Development Review Committee

Staff Report

Case No:	16DEVPLAN1007
Project Name:	Ivy Ridge Gate
Location:	4318 Ivy Crest Circle
Owners:	Ivy Ridge Patio Home Assoc.
Applicant:	Ivy Ridge Patio Home Assoc. – David Williams
Representative(s):	Goldberg Simpson, LLC. – Mark Sandlin
Project Area/Size:	19.5 Acres
Existing Zoning District:	R-5A, Multi-Family
Existing Form District:	N, Neighborhood
Jurisdiction:	Louisville Metro
Council District:	16 – Kelly Downard
Case Manager:	Joel P. Dock, Planner I

- **Revised Detailed District Development Plan (RDDDP)** for proposed gate to close secondary entrance.

2. Aerial Photograph

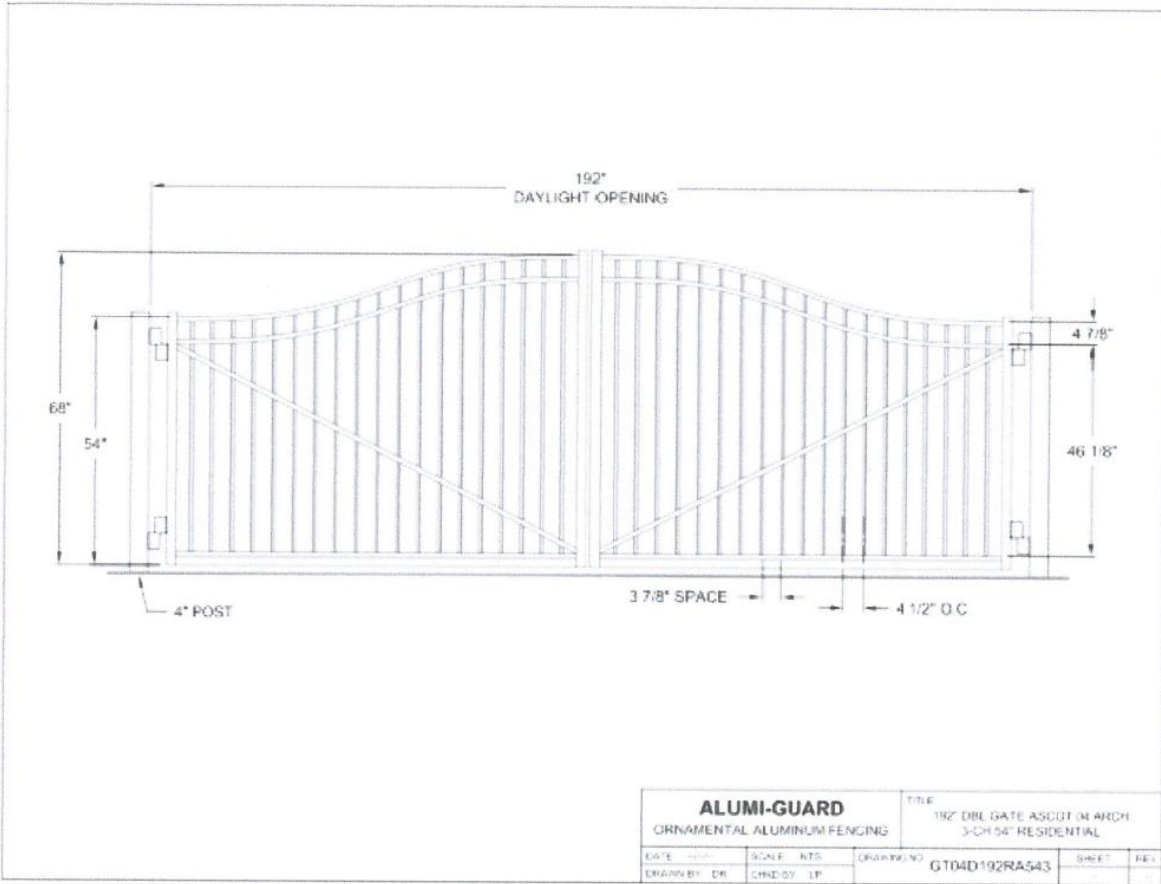
All roads within the development are private drive lanes for access to patio homes and parking areas. Land Development Code, section 6.1.3 requires developments with an aggregate of 200 or more dwellings to maintain at least two separate access points. The Ivy Ridge Patio Homes contain 92 units; thus, requiring only one access point. Harrod's Creek Fire Department emergency vehicles access Creekton Drive via Beechspring Farm Blvd. Harrod's Creek Fire has no concerns with the proposed gate.
